MINERALS PROGRAM INSPECTION REPORT
PHONE: (303) 866-3567

MINE NAME: Schwartzwalder Mine	MINE/PROSPECTING ID#: M-1977-300	MINERAL: Uranium	COUNTY: Jefferson
INSPECTION TYPE: Monitoring	INSPECTOR(S): Amy Eschberger, Tim Cazier	INSP. DATE: October 16, 2020	INSP. TIME: 12:30
OPERATOR: Colorado Legacy Land, LLC	OPERATOR REPRESENTATIVE: Billy Ray, Sam Lowe	TYPE OF OPERATION: 112d-2 - Designated Mining Operation	
REASON FOR INSPECTION: Normal I&E Program	BOND CALCULATION TYPE: None	BOND AMOUNT: \$8,900,000.00	
DATE OF COMPLAINT: NA	POST INSP. CONTACTS: None	JOINT INSP. AGENCY: None	
WEATHER: Clear	INSPECTOR'S SIGNATURE: 	SIGNATURE DATE: October 22, 2020

The primary purpose of this inspection was to observe the infill placement (concrete) for the North Waste Rock Pile (NWRP) diversion channel project approved under Technical Revision No. 28 (TR-28; approved on March 27, 2020). The Division already approved the Phase 2 construction work completed for this project during its October 8, 2020 inspection, authorizing the operator to proceed with construction as planned. The next required inspection for the NWRP diversion channel project [per Rule 7.3.1(1)] is after the project is completed. W

Photo 7. View of middle section of NWRP diversion channel, showing crew shaping final concrete placement into Geoweb cells for the day.

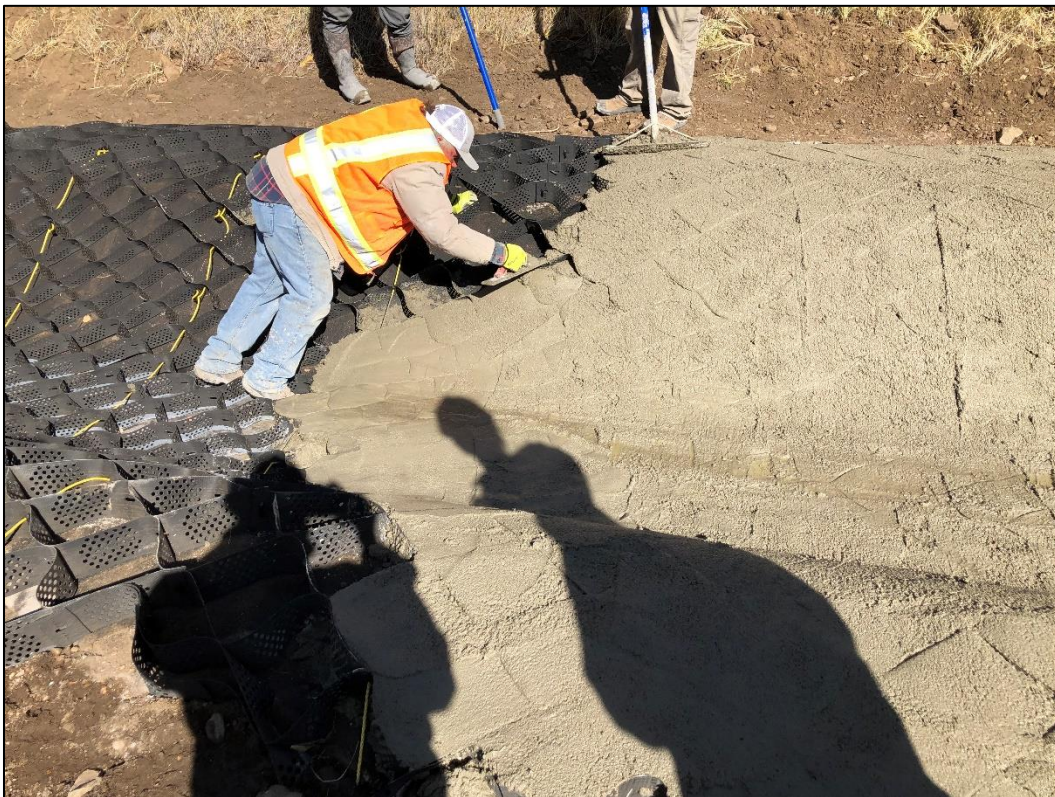
During the inspection, a concrete truck was on site and the crew was placing concrete into the Geoweb panels installed in the diversion channel. According to the operator, installation of the Geoweb components in the channel was completed the week before the inspection and concrete placement began at the top of the channel the morning before the inspection (Thursday). Approximately 36 cubic yards (cy) of concrete had been placed on Thursday, and approximately 24 cy was expected to be placed the day of the inspection (Friday). At the time of the inspection, the operation had received the last concrete load for the day, and finished filling a little more than half of the total channel length (approximately 600 feet). The operator appeared to be following the manufacturer's recommendations, including leaving no Geoweb cells partially filled in between concrete pours. The next concrete delivery was scheduled for Monday morning (October 19).
